ADDENDUM 03

PROJECT NUMBER | 1910404.00

Date | 11/23/2021

PROJECT | Yorktown Central School District
District Wide Improvements 2020 Phase II

YHS-E104

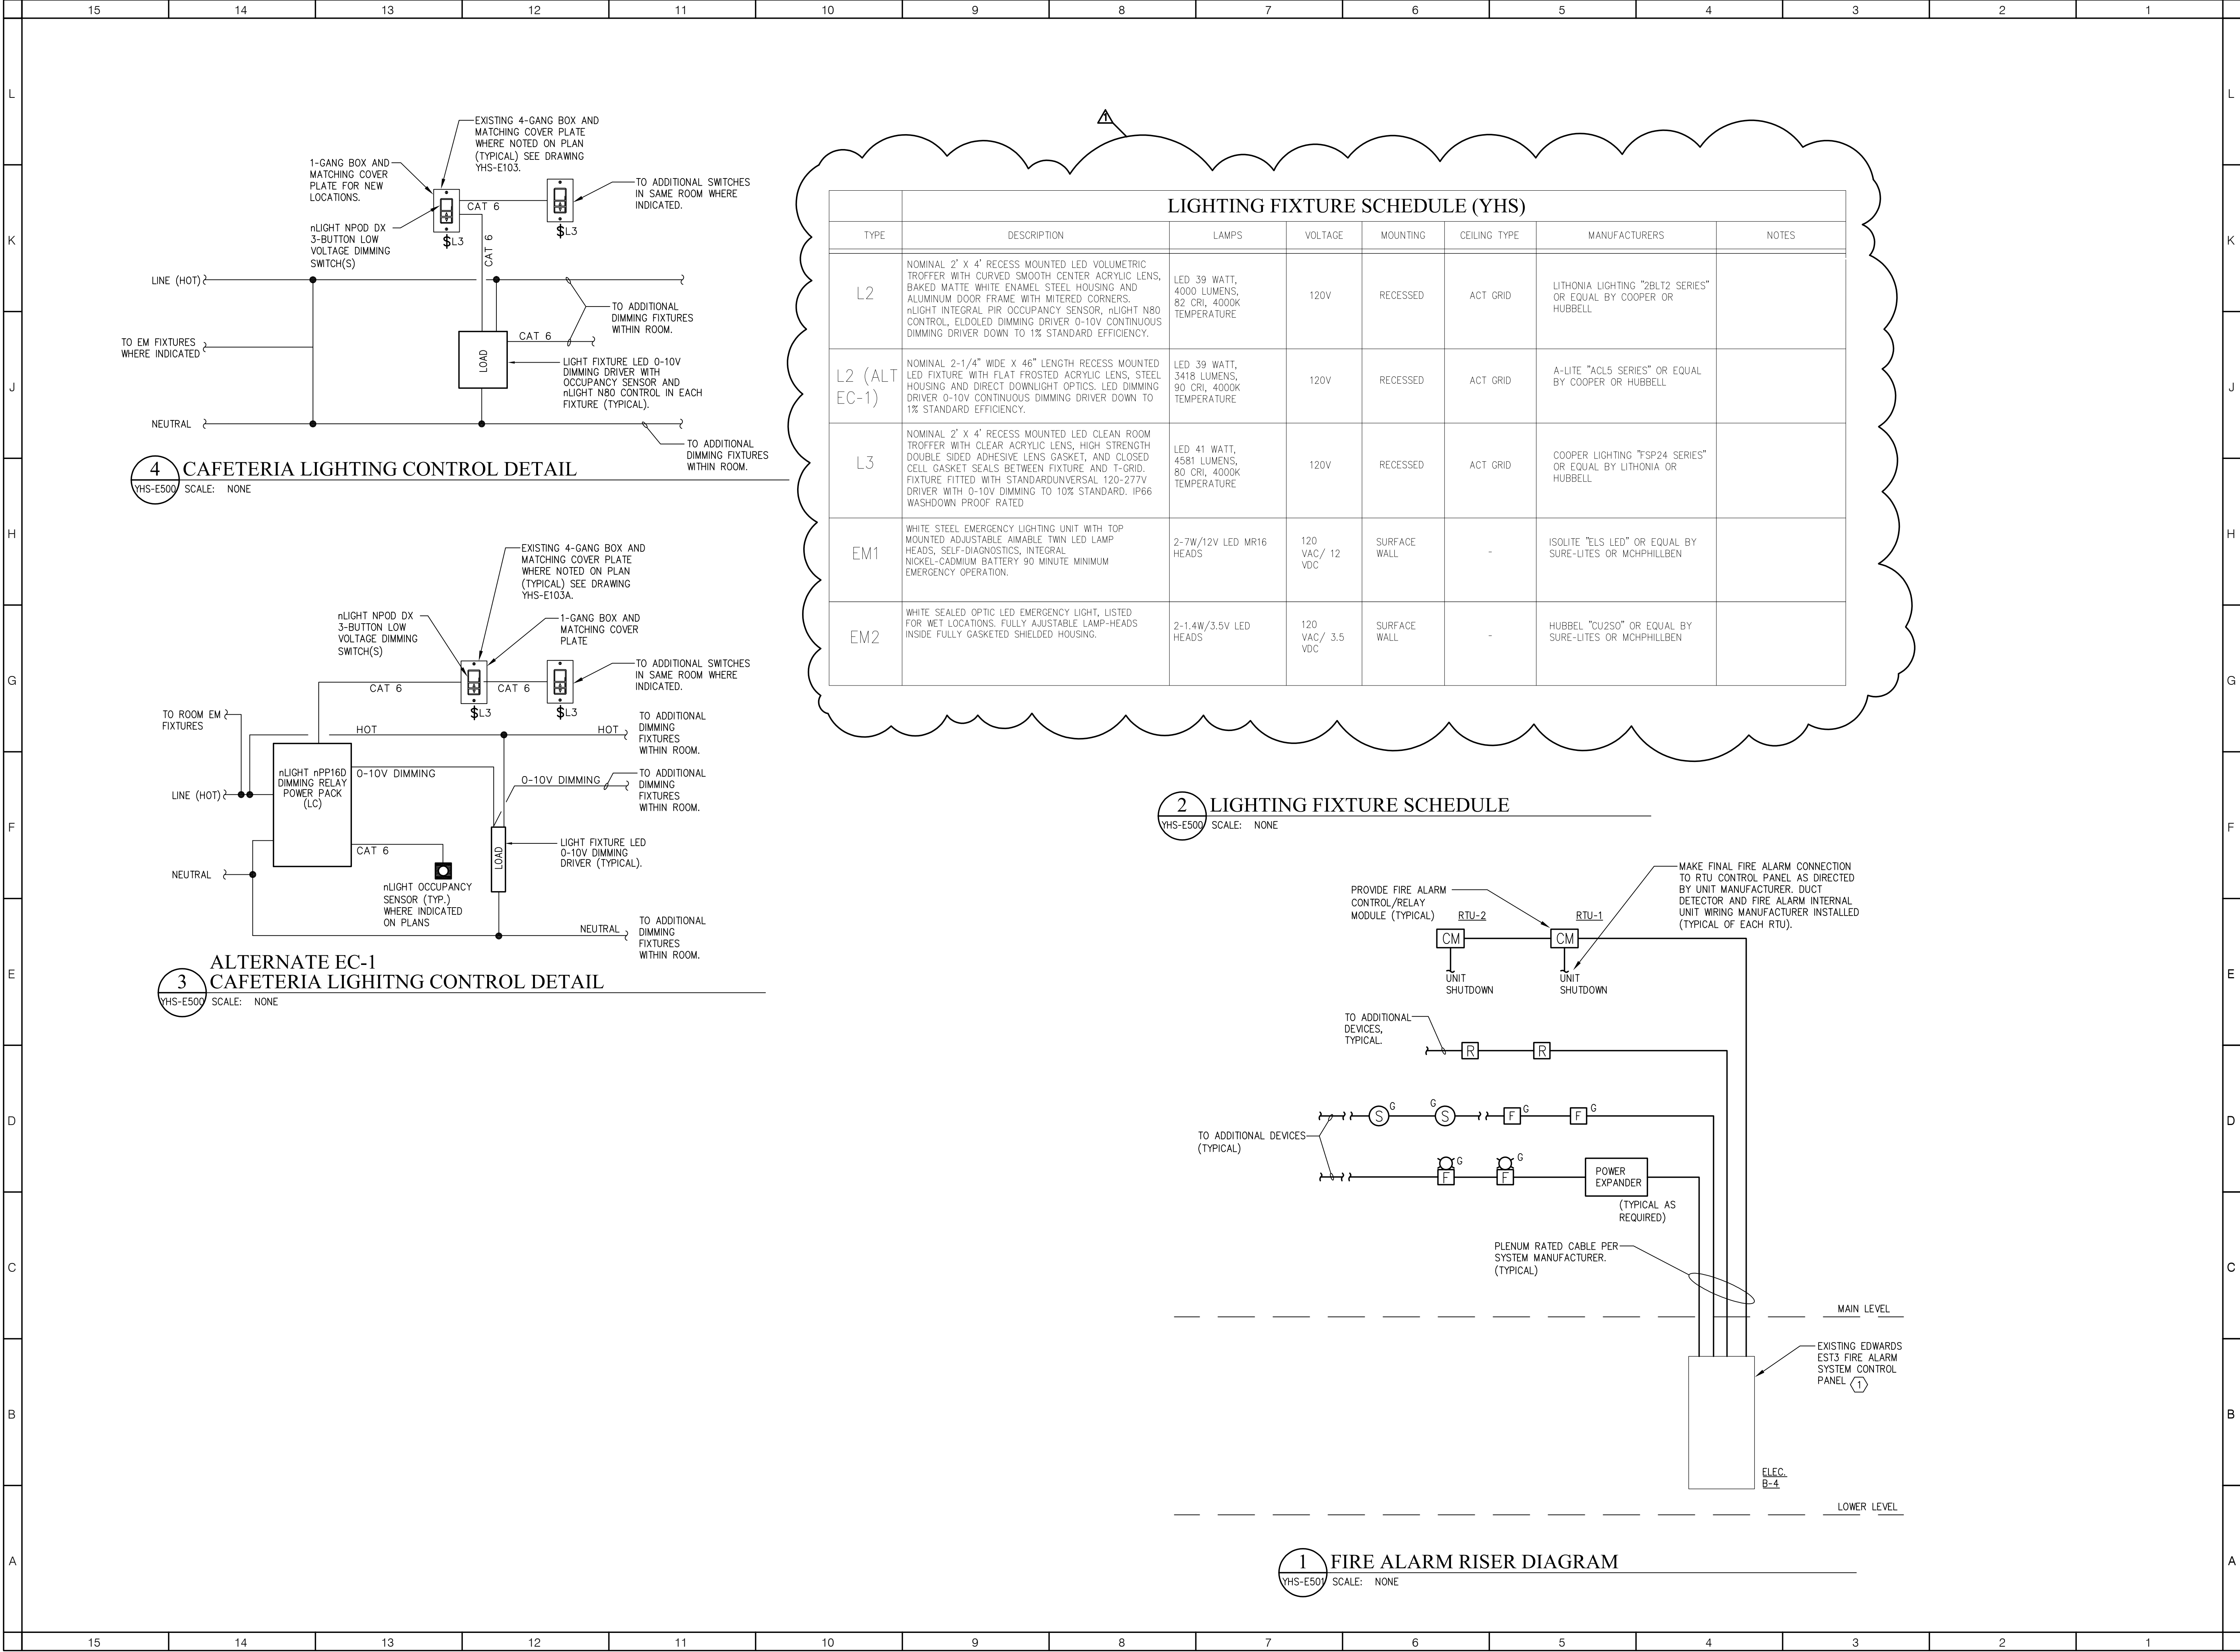
5. RFI Question: On Drawing No. YHS-E000 and YHS-E104 they indicate New Panel PP-HSAC. Please confirm this panel is new or existing (installed as part of another project). On Drawing No. YHS-E000 in the panel schedule they indicate RTU-1 and RTU-2 for the GYM North and South which I think was a project from last year? Please confirm exact scope of work and if it is new are RTU-1 and RTU-2 for future work as they are not shown on the electrical drawings?

- a. **RTU-1 and RTU-2 are existing to remain. Panel PP-HSAC was installed in pervious project and is existing to remain. Panel PP-HSAC currently serves RTU-1 and RTU-2 and currently has a spare breaker that will serve RTU-3. Refer to updated sheet YHS-E000 and YHS-E104 for more information.**

YHS-E500

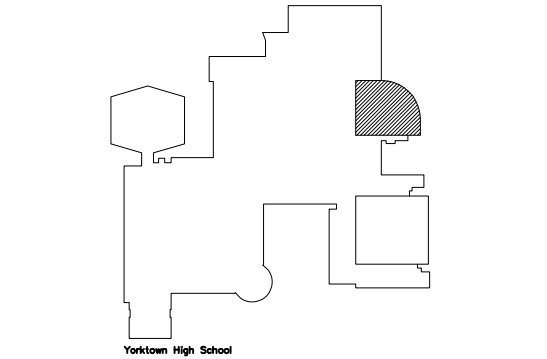
- b. **Color shall be picked by the Architect/Owner from the available standard color chart.**
4. RFI Question: On Drawing No. YHS-E500 in the Light Fixture Schedule they indicate a Type L1 which is an LED high bay light fixture that is used in the Gym at the other schools. Please confirm if this light fixture type is used for Yorktown High School project, if so please forward a corresponding drawing for these light fixture quantities, or should this light fixture type be removed from the Light Fixture Schedule.

- a. **DELTA- Fixture type 'L1' was shown on sheet YHS-E500 in error and has now been removed. Each school drawing set has its own light fixture schedule. Light fixtures for a specific school are to be based on the individual school's light fixture schedule.**
